<b>Address:</b>	Vine House Hampstead Square London NW3 1AB		<b>13</b>
<b>Application Number:</b>	2015/4748/P	<b>Officer: Kate Phillips</b>	
<b>Ward:</b>	Hampstead Town		
<b>Date Received:</b>	19/08/2015		
<b>Proposal: Erection of a two storey outbuilding to provide a garage and office at ground level and living accommodation at first floor level, with a car port at the front, following the demolition of the existing outbuilding; and associated works.</b>			
<b>Background Papers, Supporting Documents and Drawing Numbers</b> VH-PL-01; VH-PL-02; VH-PL-03; VH-PP-03; VH-PL-08; VH-PL-09; VH-PL-10; VH-PP-11; VH-PP-14; VH-PP-29; VH-PL-11; VH-PL-12; VH-PL-13; VH-PL-14; VH-PL-15; VH-PL-16; VH-PL-17; VH-PL-18; VH-PL-19; VH-PL-20; VH-PL-20 Proposed Streetscape; Heritage Statement (dated August 2015); Design & Access Statement (dated August 2015).			
<b>RECOMMENDATION SUMMARY: Grant conditional planning permission</b>

## **OFFICERS' REPORT**

**Application No: 2015/4748/P & 2015/5275/L**  
**Vine House**  
**Hampstead Square**  
**London**  
**NW3 1AB**

# Proposed floor plans

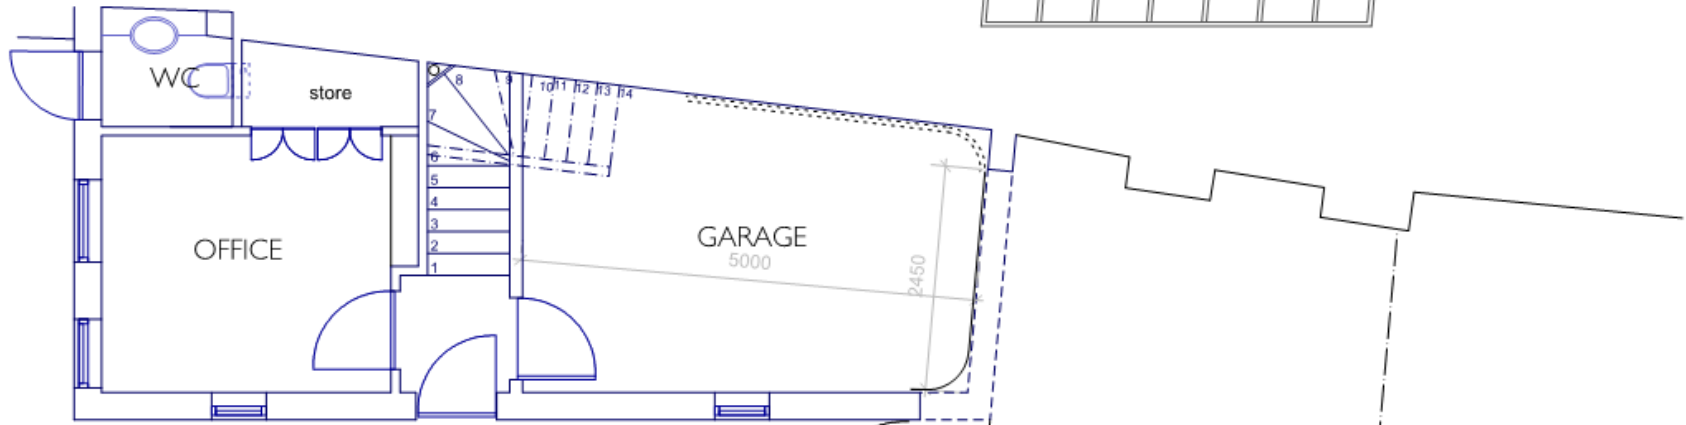
(paving lowered by 330mm)
